# UNITED STATES PATENT AND TRADEMARK OFFICE

10/630,504	07/30/2003	Jane Xin-LeBlanc	P05725	7910
------------	------------	------------------	--------	------

<b>Office Action Summary</b>	<b>Application No.</b>		<b>Applicant(s)</b>	
	10/630,504		XIN-LEBLANC ET AL.	
	<b>Examiner</b>		<b>Art Unit</b>	
	Jeff Natalini		2858

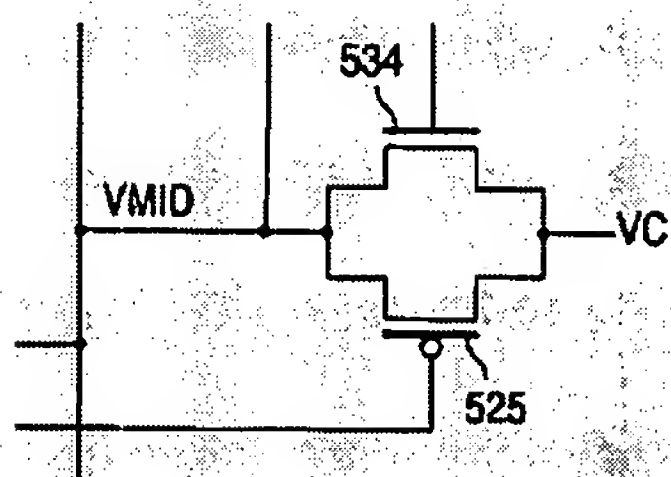
The drawings are objected to under 37 CFR 1.83(a). The drawings must show every feature of the invention specified in the claims. Therefore, the "second impedance circuit coupled between said first internal node and a ground rail, wherein said first and second impedance circuits form a voltage divider circuit that biases said first internal node to a target bias voltage when said test signal is disabled" as claimed in claim 4 must be shown or the feature(s) canceled from the claim(s). No new matter should be entered.

Corrected drawing sheets in compliance with 37 CFR 1.121(d) are required in reply to the Office action to avoid abandonment of the application. Any amended replacement drawing sheet should include all of the figures appearing on the immediate prior version of the sheet, even if only one figure is being amended. The figure or figure number of an amended drawing should not be labeled as "amended." If a drawing figure is to be canceled, the appropriate figure must be removed from the replacement sheet, and where necessary, the remaining figures must be renumbered and appropriate changes made to the brief description of the several views of the drawings for consistency. Additional replacement sheets may be necessary to show the renumbering of the remaining figures. The replacement sheet(s) should be labeled "Replacement Sheet" in the page header (as per 37 CFR 1.84(c)) so as not to obstruct any portion of

This is from fig 5:

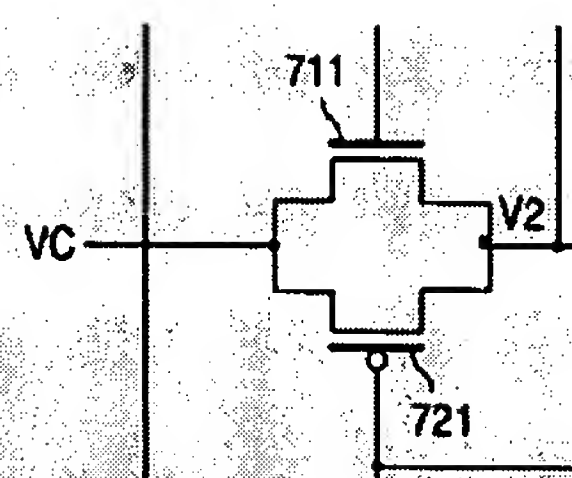
In the specification pg 21 line 14-18, it is disclosed that the source of transistor 534 is coupled to the VMID node, and the drain is coupled to the VC node.

So it is seen the applicant has switched the transistors drain and source terminals as disclosed in two different figures. Please correct all drawings so the drain and source terminals are not switched or provide some arrow or other indication thus allowing one skilled in the art to easily identify the drain and source terminals.
